SAN FRANCISCO ELECTRIC RELIABILITY PROJECT (04-AFC-1)

DATA RESPONSE, SET 1A (Responses to Data Requests: 1 through 91)

Submitted by
CITY AND COUNTY OF SAN FRANCISCO

July 6, 2004

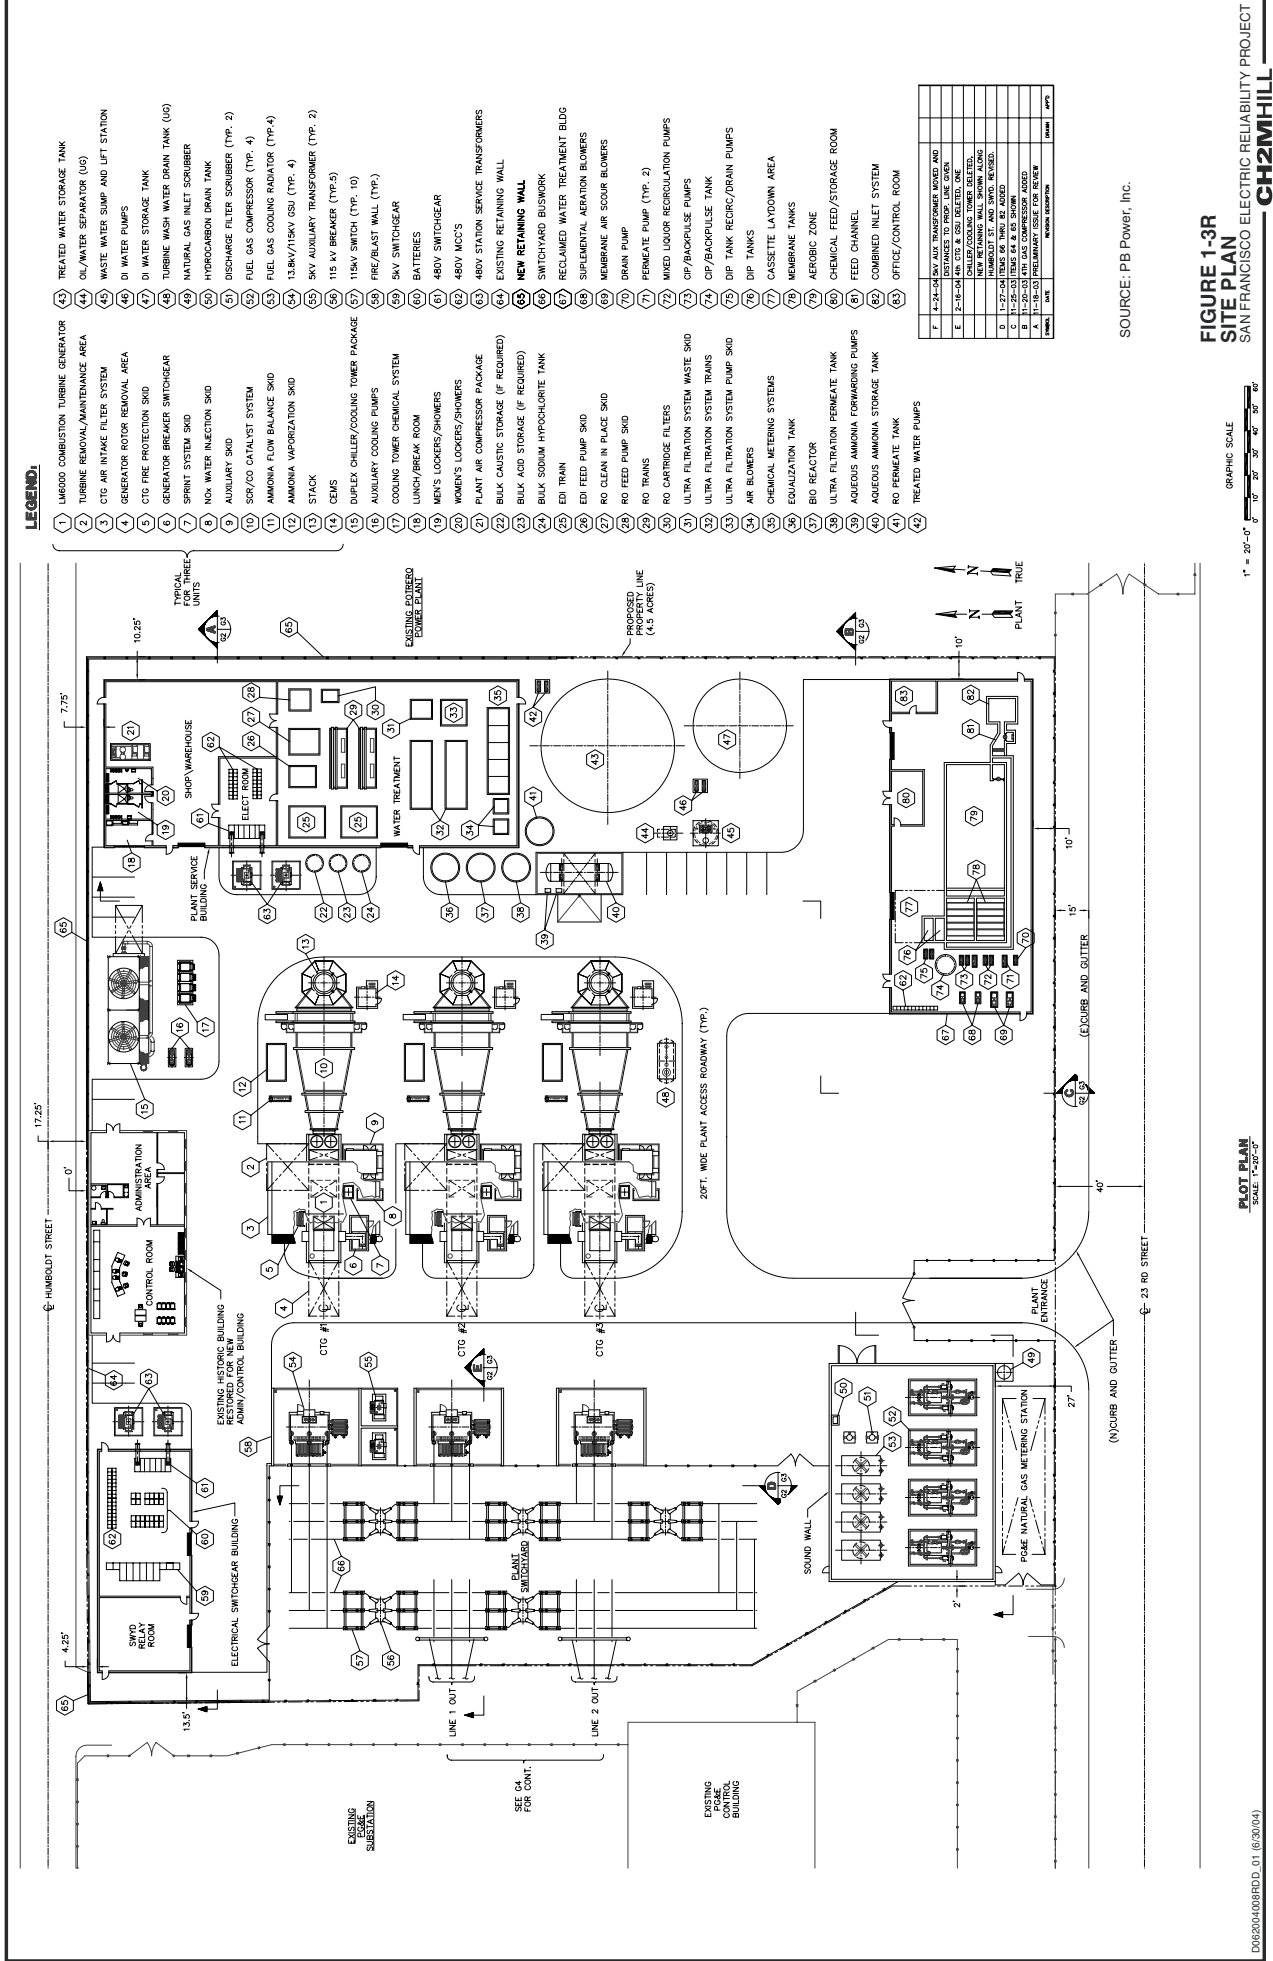
38. Provide the location, layout and numbers of parking spaces to be developed on the site. This information may be included in the revised Figure 1.3 Site Plan, or in a separate, related exhibit.

Response: Refer to AFC Figure 1-4, Site Layout which shows the preliminary location and number of plant parking spaces just to the west of water storage tanks #43 and #47. Also, Revised Figure 1-3R (Data Response #35) shows a closer view of the parking spaces.
